## TEXAS COMMISSION ON ENVIRONMENTAL QUALITY

January 10, 2008

Re: Edwards Aquifer, Comal County  
NAME OF PROJECT: Copper Ridge; Located on the south side of Highway 46, two miles west of FM 2722; New Braunfels ETJ, Texas  
TYPE OF PLAN: Request for Approval of a Water Pollution Abatement Plan (WPAP); 30 Texas Administrative Code (TAC) Chapter 213 Edwards Aquifer  
Edwards Aquifer Protection Program ID No. 2726.00; Investigation No. 598538; Regulated Entity No. RN105363956

# Sensitive Feature Setbacks Copper Ridge Site Plan 1" = 400'

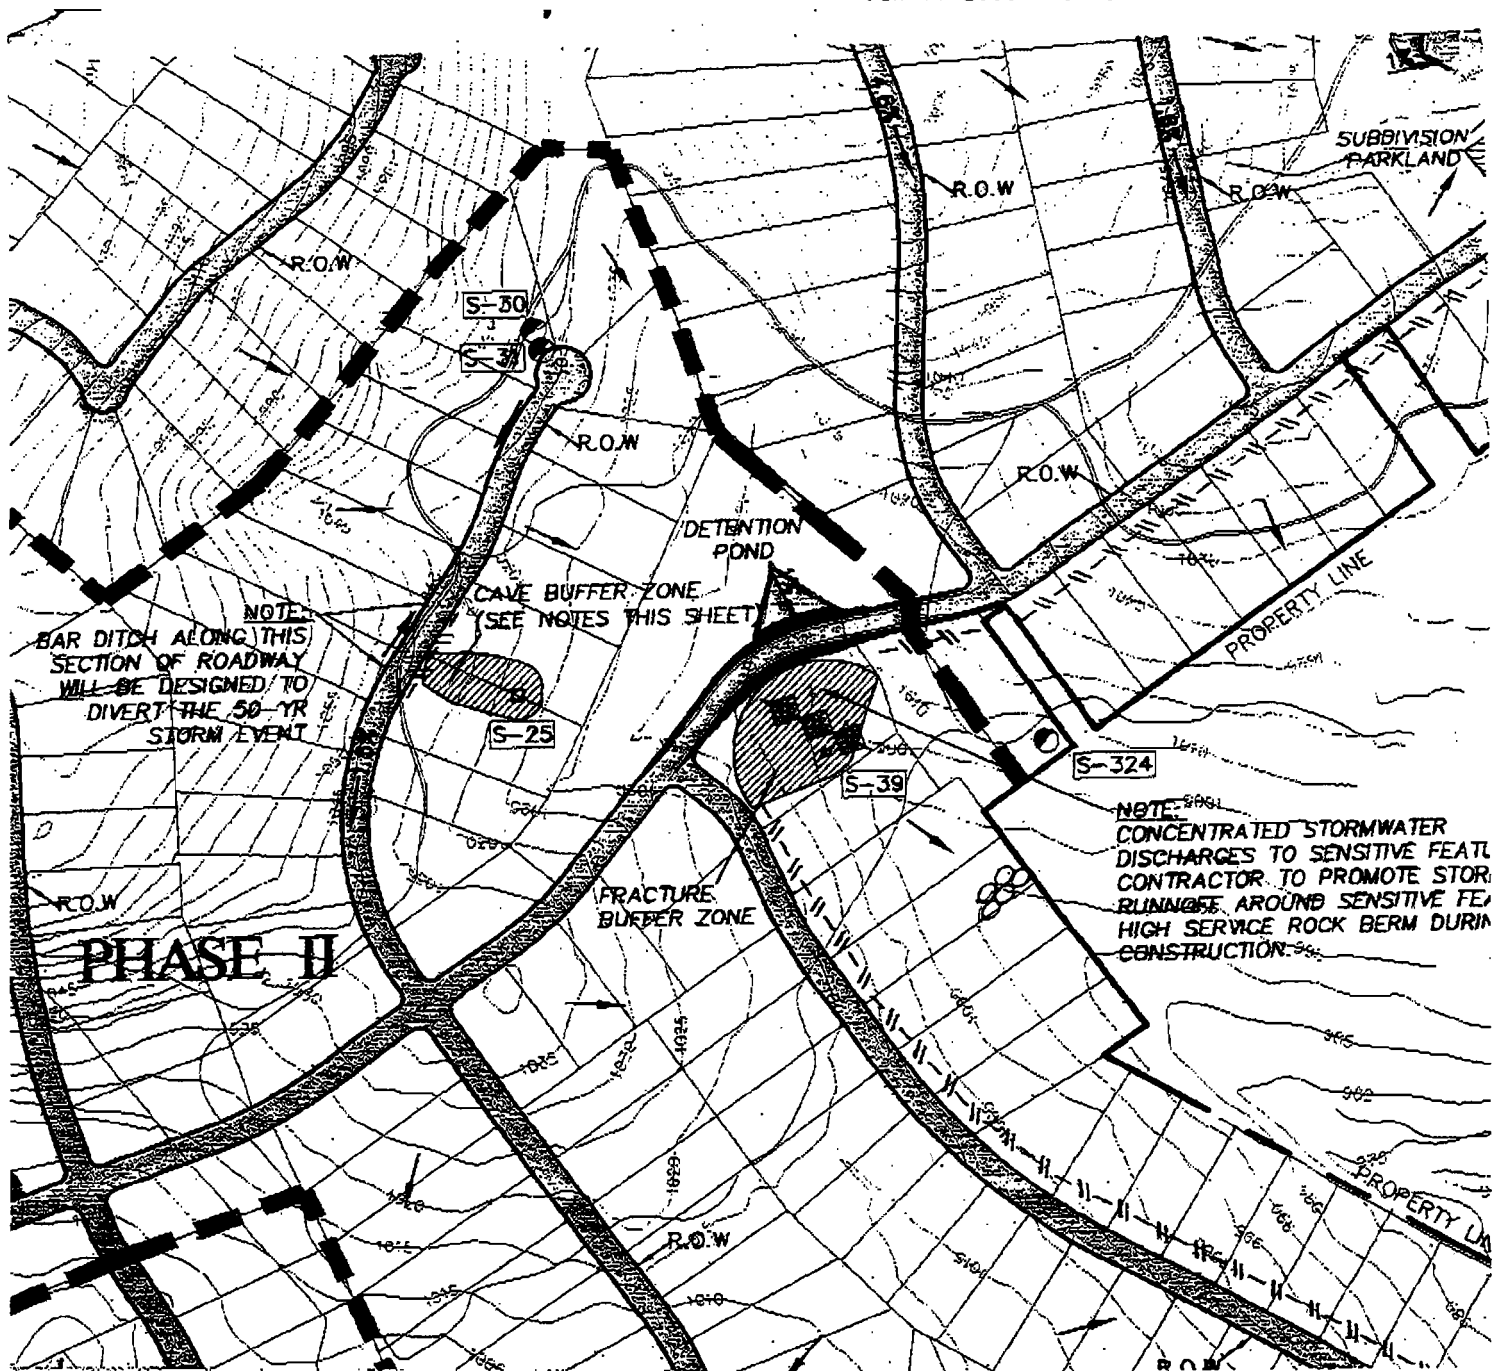
Since this single-family residential project will not have more than 20 percent impervious cover, an exemption from permanent BMPs is approved. The permanent natural buffer areas for sensitive features were designed using the TCEQ technical guidance document Complying with the Edwards Aquifer Rules: Technical Guidance on Best Management Practices (2005). The individual buffer areas for sensitive features can be seen in the enclosed Attachment A, taken from the WPAP, "Site Plan for Copper Ridge". Temporary BMPs, silt fence and high service rock berms will be installed during construction activities. The natural buffer area will be shown on the subdivision plat and on respective lot plats as a construction free area.

According to the geologic assessment included with the application, eight sensitive geologic and manmade features were evaluated at the project site. Five of the eight features were manmade water wells. The San Antonio Regional Office site assessment conducted on December 3, 2007 revealed the site as described by the geologic assessment and site plan. The following table summarizes the sensitive features and the BMP measures for each feature.

Feature S-217 is an inferred fault that runs along a streambed parallel to Highway 46, crosses the northern edge of the property and extends beyond the property boundaries. As noted by the project geologist during the field inspection, fractures were present in this area of the streambed. The proposed roadway into the subdivision crosses this fault. The natural buffer area will not be provided and part of the fault will be sealed by the roadway. Justification for sealing the feature is based on the width of the roadway compared to the total length of the fault and maintaining natural flow. In this area, the property boundary and fault width is approximately 200 feet wide and the roadway will be approximately 85 feet wide. The roadway only crosses a small portion of the fault based on the total length. Secondly, natural flow will be maintained and the right of way areas will be kept in a natural state to the maximum extent possible. Culverts will be constructed to control stormwater, including flood events, and pass the stormwater under the roadway. Riprap will be located on downstream end of the culverts to control stormwater velocities. The remaining fault line and streambed will be kept in the natural state.

# Site Geologic Map

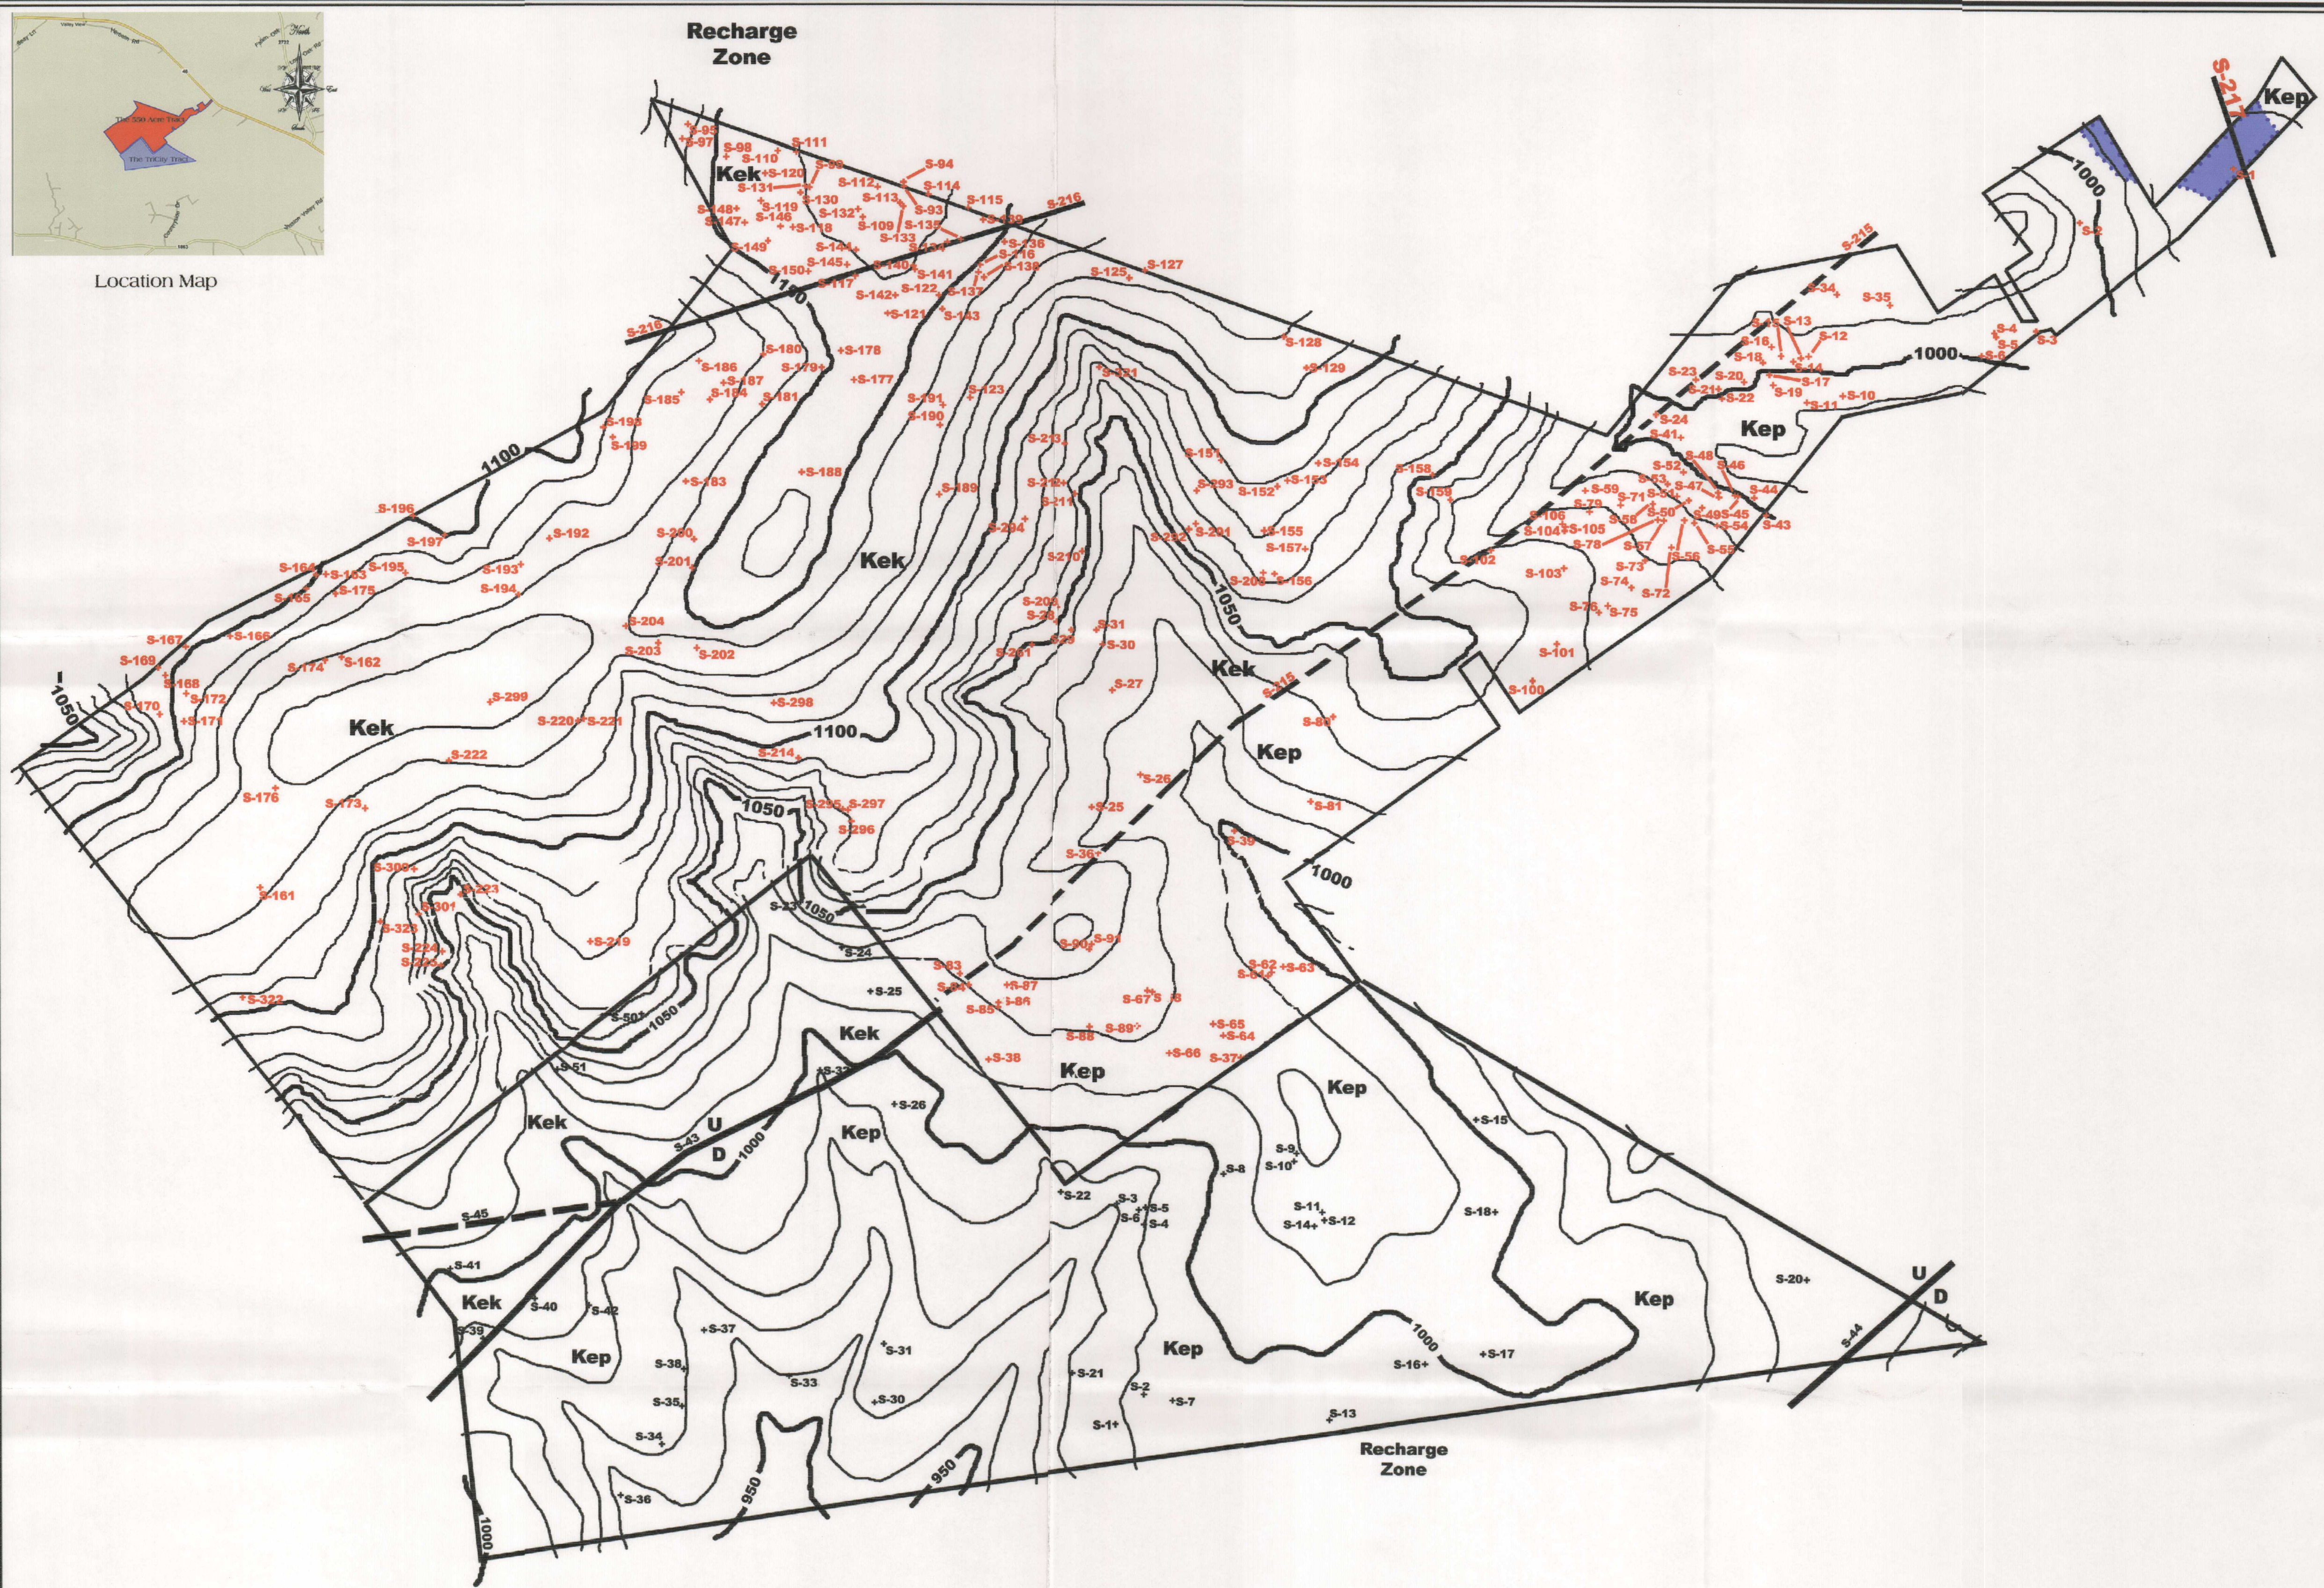
8. Verify the contour elevations on the geologic map, specially the southwest corner of the property. Revise as necessary. Provide this revised map prior to the site assessment (if the site assessment is scheduled prior to the response due date).

See Revised Geologic Map attached
